# BCA Assessment Report

Schematic Design – REF Submission  
World Class End of Life Program  
Westmead Hospital

**Revision 3**  
21 August 2024  
Reference: 230221

Figure No. 2 – Roof Plan showing the location of the proposed skylight in proximity to the external wall of the CASB

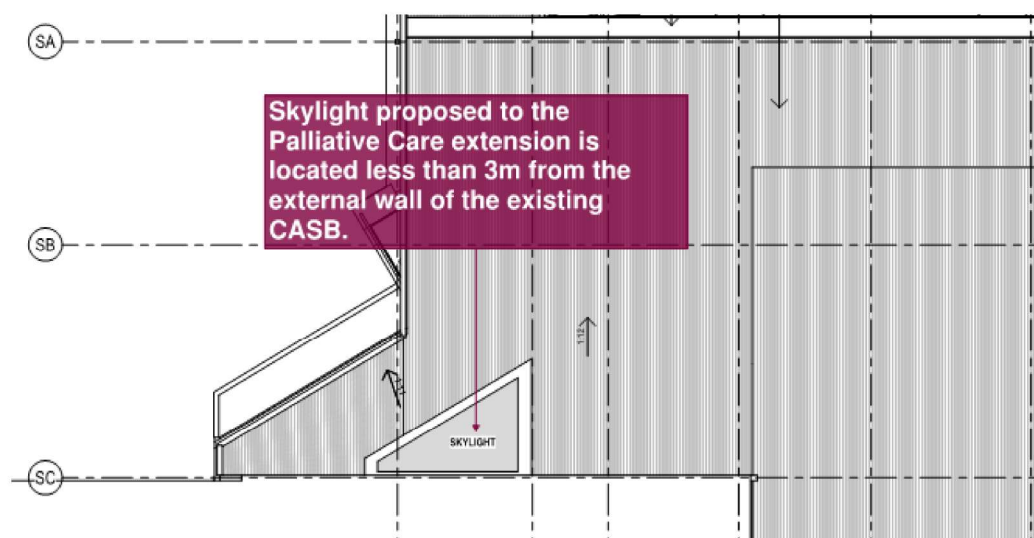
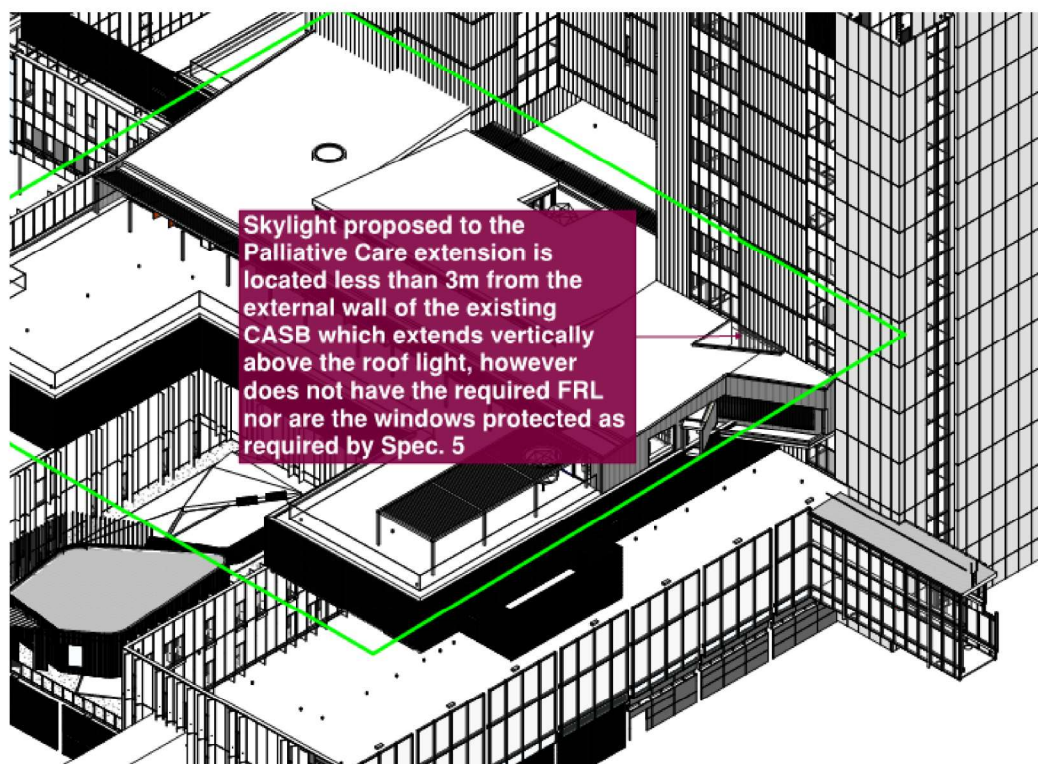
Having regard to the proposed design, the triangular skylight to the Palliative Care extension is located within 3m of the external wall of the CASB which extends vertically above the proposed skylight. The existing external wall of the CASB is not fire rated nor are window openings protected as required by Specification 7 of the BCA. Refer to figures below.

Having regard to the above, the skylight will need to be relocated so that it is a minimum of 3m from the external wall of the CASB or alternatively the proposed design will be required to be assessed by the Fire Safety Engineer to determine if the non compliance with Specification 7 can be assessed as part of the Fire Engineering Assessment.

Figure No. 6: Proposed smoke compartment sizes that will exceed the maximum limitations of Clause C3D6

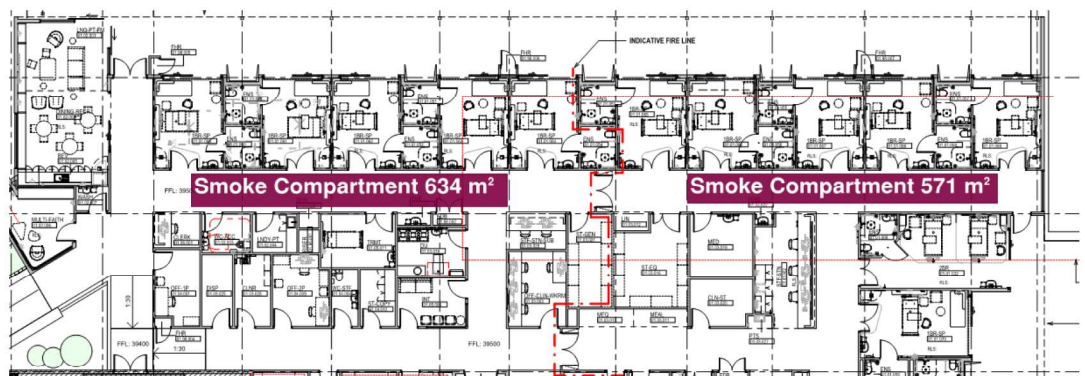
The smoke compartment sizes are proposed to be addressed as part of the Fire Engineering Assessment to be undertaken by the Fire Safety Engineer to demonstrate compliance with the nominated Performance Requirements of the BCA.

Figure No. 9: Fire safety doors that are proposed not to swing in the direction of egress

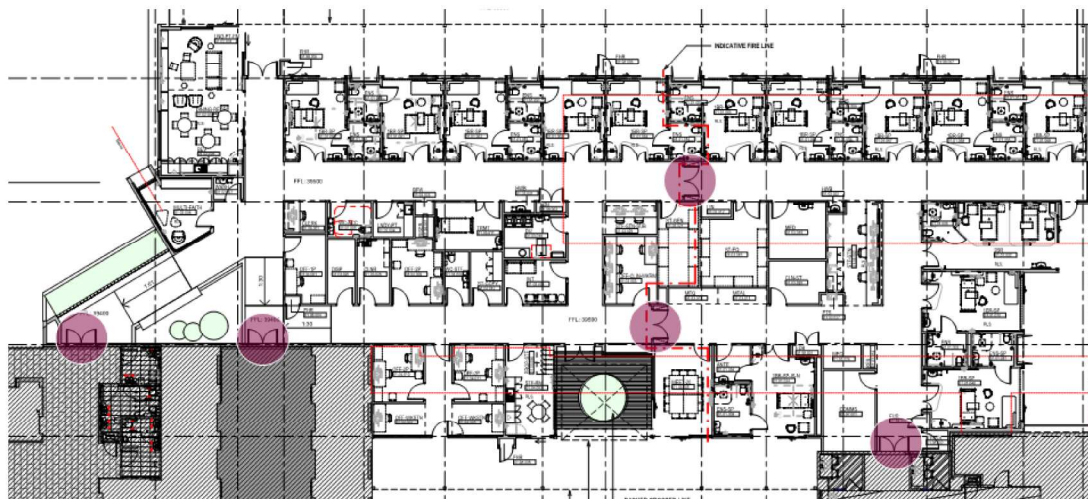
It is noted that all of fire safety doors are proposed to swing in one direction only as detailed in the figure below.

The swing of the doors will be required to be addressed as part of the Fire Engineering Assessment to be undertaken by the Fire Safety Engineer in order to demonstrate compliance with the nominated Performance Requirements of the BCA.

Figure No. 11: Available exits from the proposed Palliative Care Unit

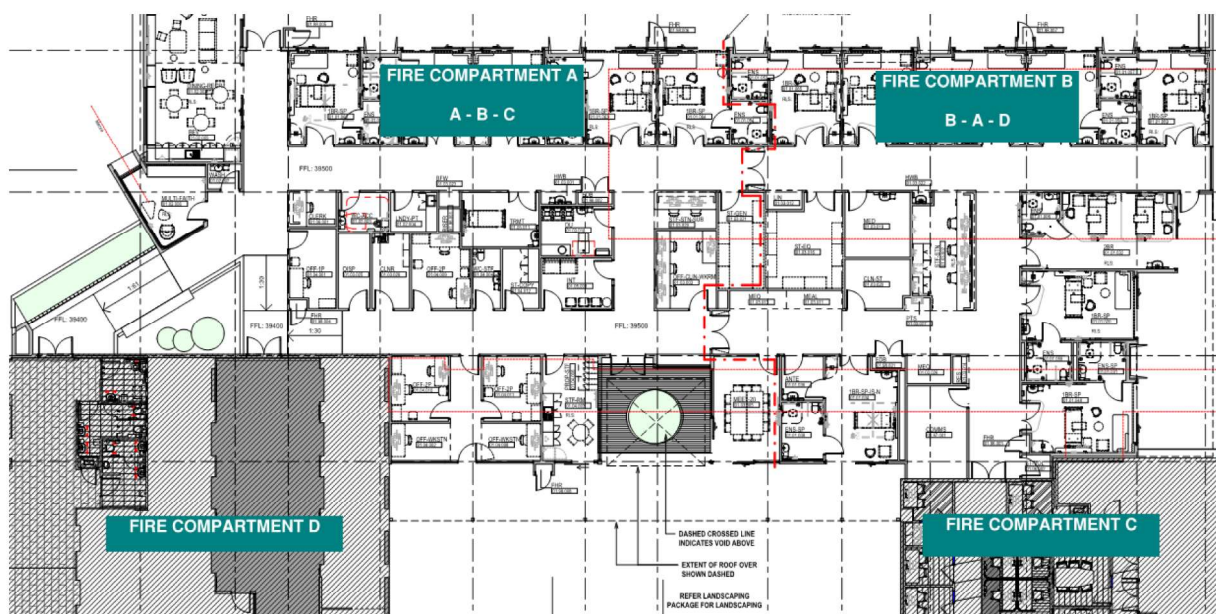
The following figure details the examples of travelling via the horizontal exits serving the palliative care unit.

Travel via the horizontal exits serving the palliative care unit will be required to be assessed as part of the Fire Engineering Assessment to be undertaken by the Fire Safety Engineering to demonstrate compliance with the nominated Performance Requirements of the BCA.

Figure No. 16: Sliding doors located within the patient care area

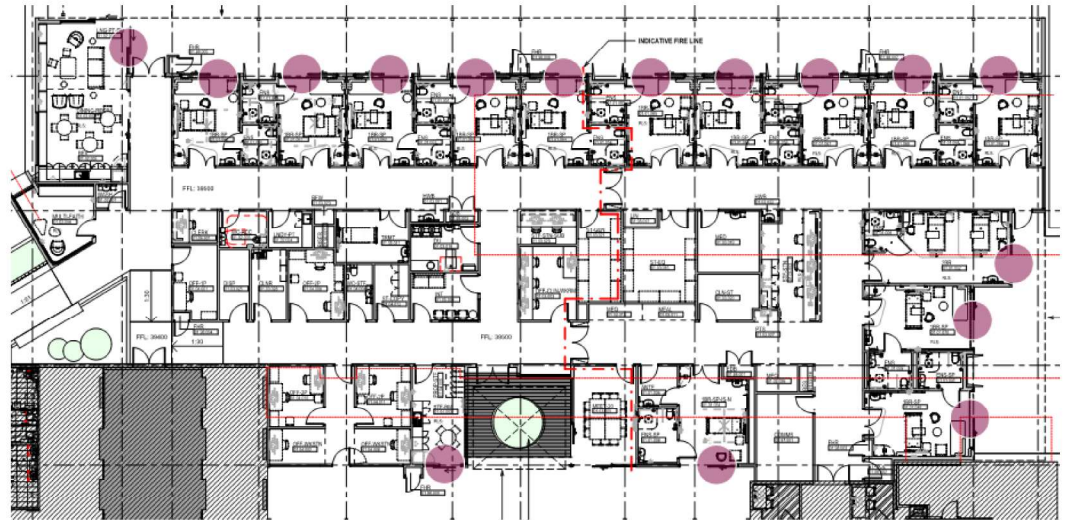
The provision of sliding doors within patient care areas as identified on the drawings will be required to be assessed as part of a Fire Engineering Assessment to be undertaken by the Fire Safety Engineer to demonstrate compliance with the nominated Performance Requirements of the BCA.

Figure No. 22: Circulation Space dimensions at swing doors

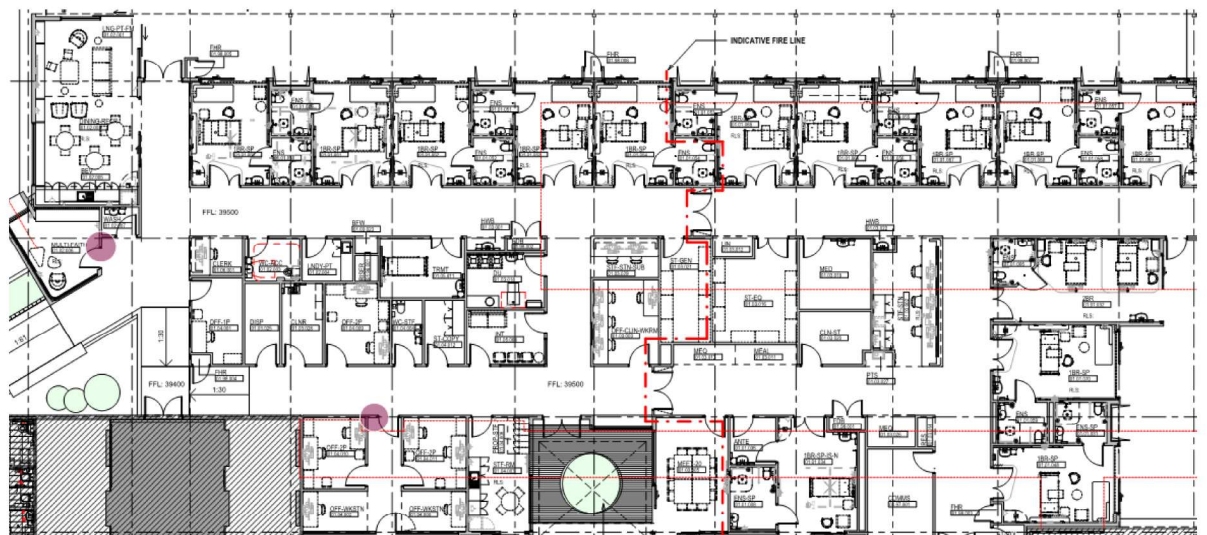
The below figure details doorways that require close attention to ensure that compliant latchside circulation space is provided.

Figure No. 31: Room that may be subject of an exemption for no access for a person with a disability subject to confirmation from the LHD

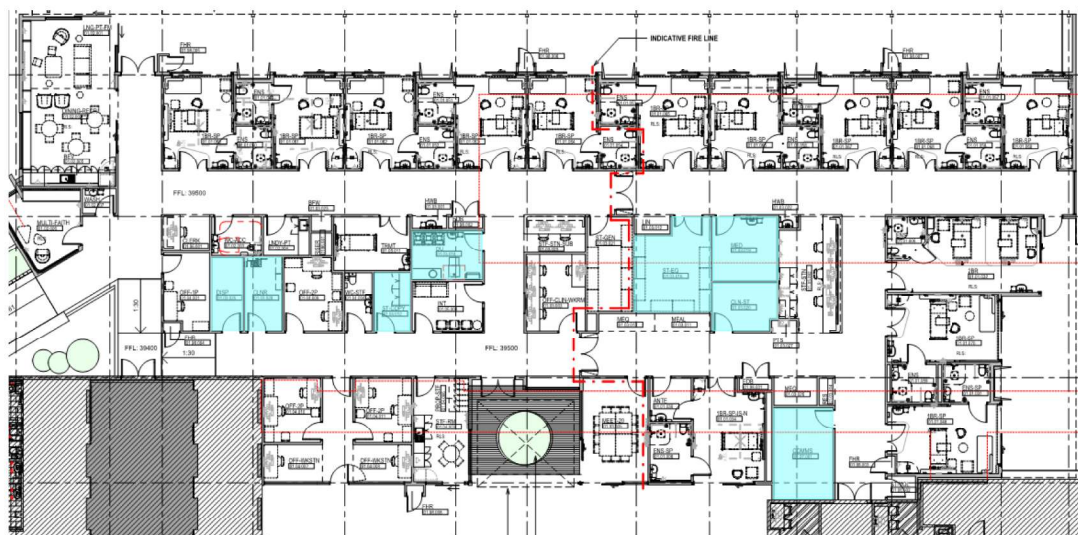
Areas / rooms that may not be required to be accessible for a person with a disability include the following (which are identified in the figure below):

The LHD are to provide written confirmation that access for any staff members with a disability is not required to be provided to the abovementioned rooms.

Figure No. 32: Internal fire hose reels located more than 4 m from an exit to be installed adjacent to an internal fire hydrant

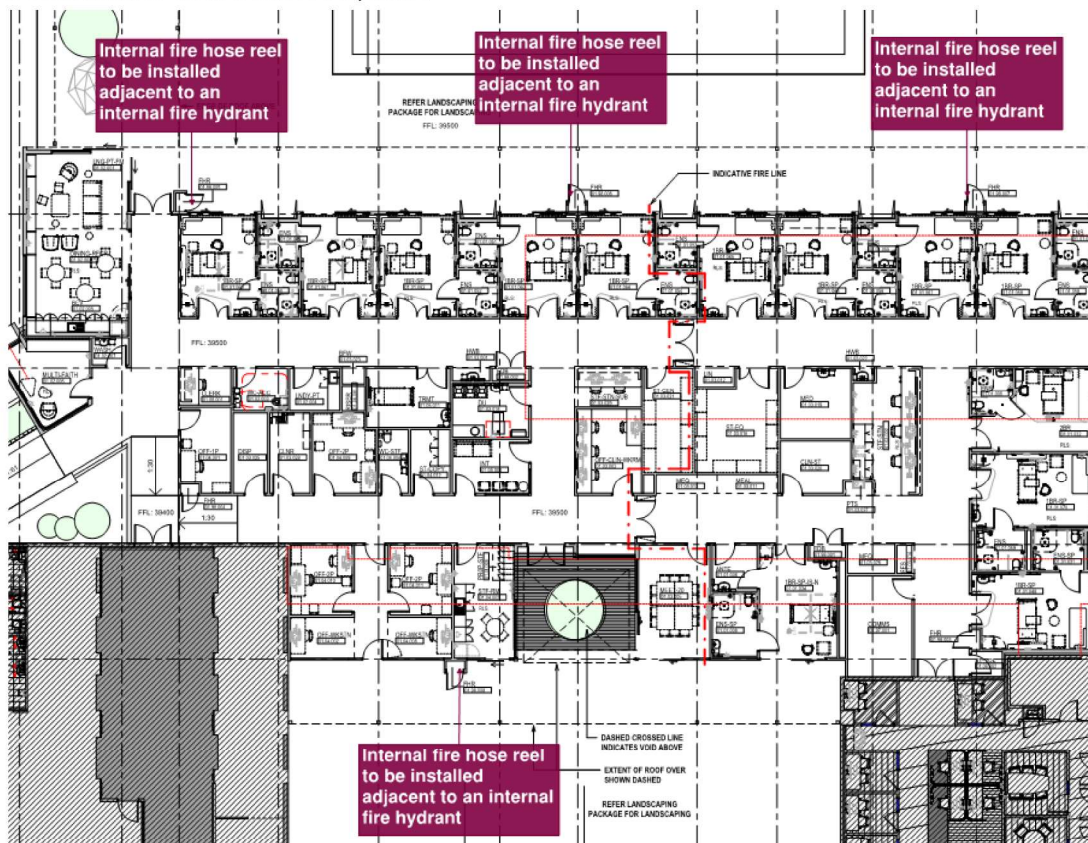
Compliant fire hose reel coverage will be required to be provided to the terrace (occupiable outdoor areas). All fire hose reels installed to provide coverage to the terrace will be required to be installed to an internal fire hydrant.

Figure No. 33: Compliant fire hose reel coverage not proposed to be provided to the fire separate Comms Room

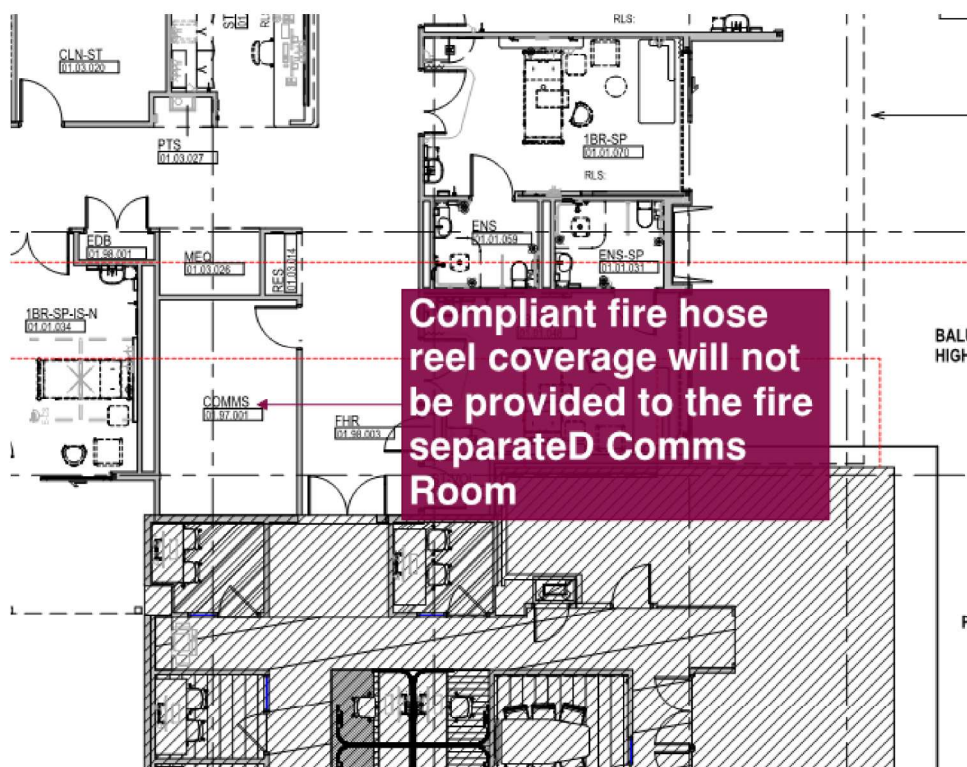
In this instance, the omission of Fire Hose Reel coverage to the fire separated isolated room will be required to be assessed as part of the Fire Engineering Assessment to be undertaken by Arup to demonstrate compliance with the nominated Performance Requirements of the BCA.

Figure No. 35 Ambulant sanitary compartment required to be provided for staff

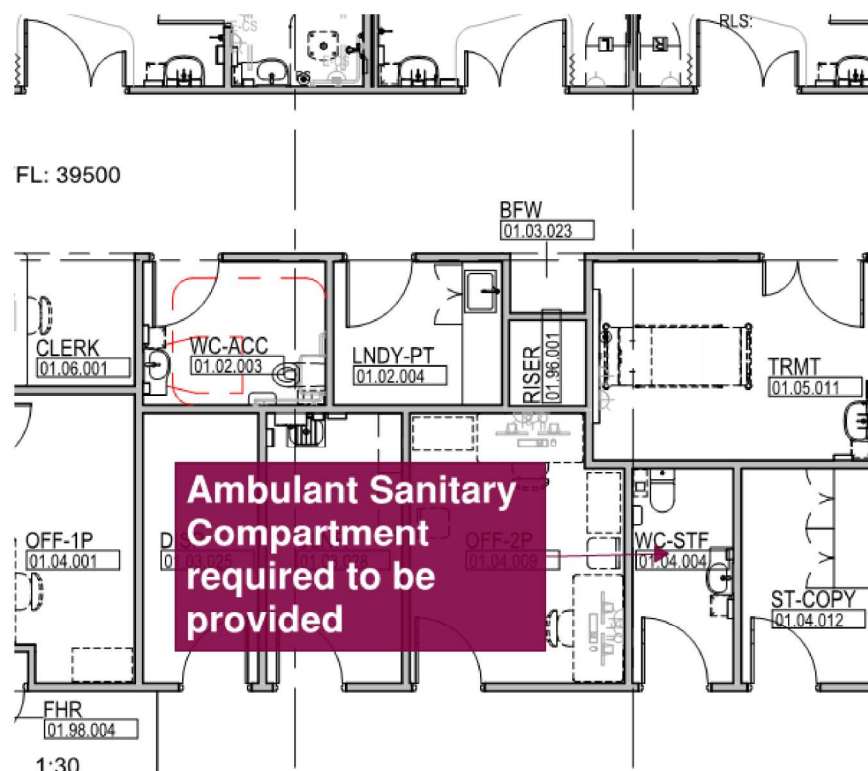
The staff sanitary facility will be required to be designed as an Ambulant Sanitary Compartment in accordance with A 1428.1 – 2009.
